P 36030

A REPAIR

SEWAGE DISPOSAL SYSTEM

PROPERTY OWNER Simkins Industries
River Road

A 36030
Repair

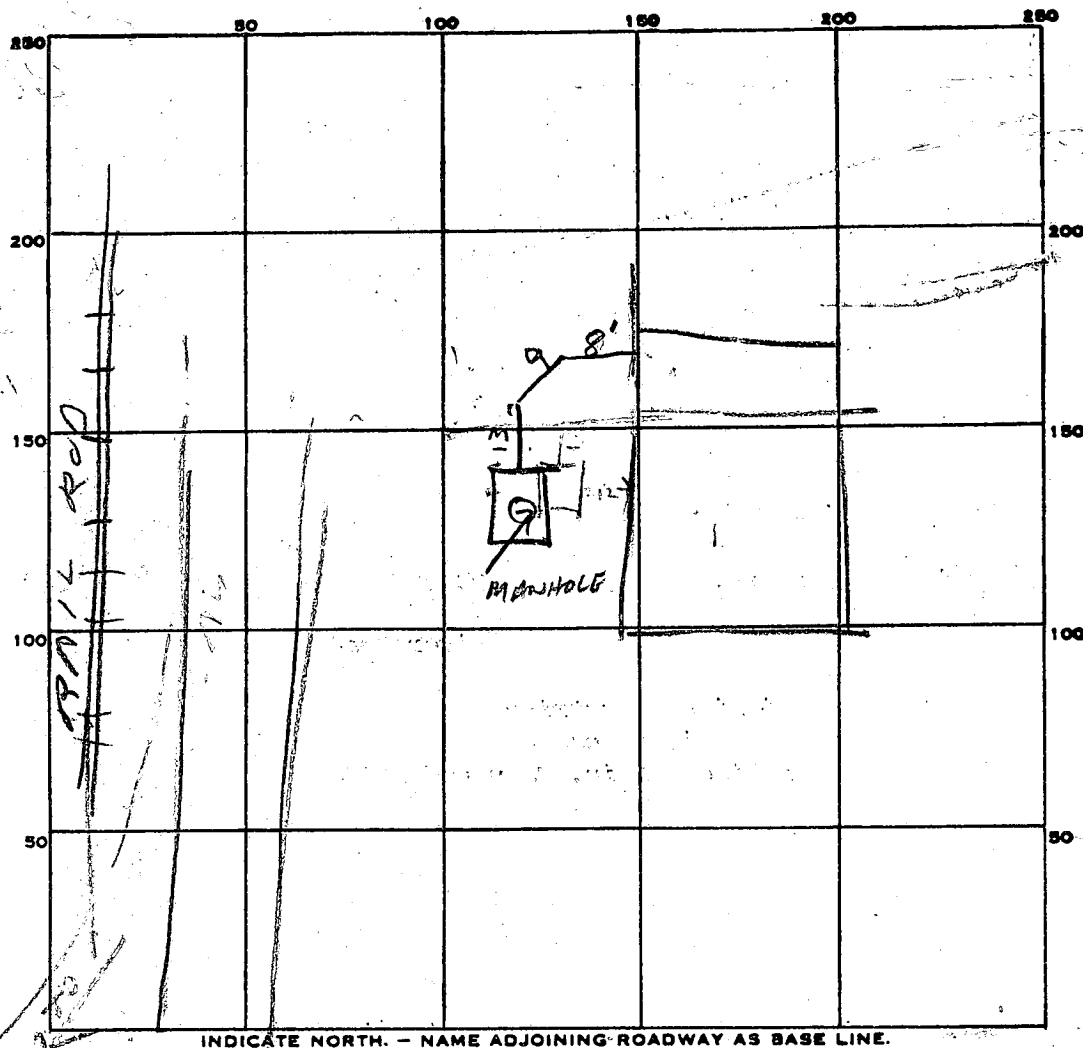
REMARKS 11/8/85 - 2000 GAL TANK SET. HOOK UP TANK.

INSTALL ALARM SYSTEM AND MANHOLE & CALL RH.

11-15-85 ALARM IN PLACE - TEST FUNCTIONING; ALL PLUMBING IN
EXISTING BR (ie. SHOWER, SINK, AND TOILET) DISCONNECTED; SINK IN CHEMICAL
LAB CONNECTED TO STAINLESS STEEL TANK IN BASEMENT w/ DISCHARGE TO RIVER;
PERMIT FOR DISCHARGE TO BE MAILED TO OUR OFFICE.
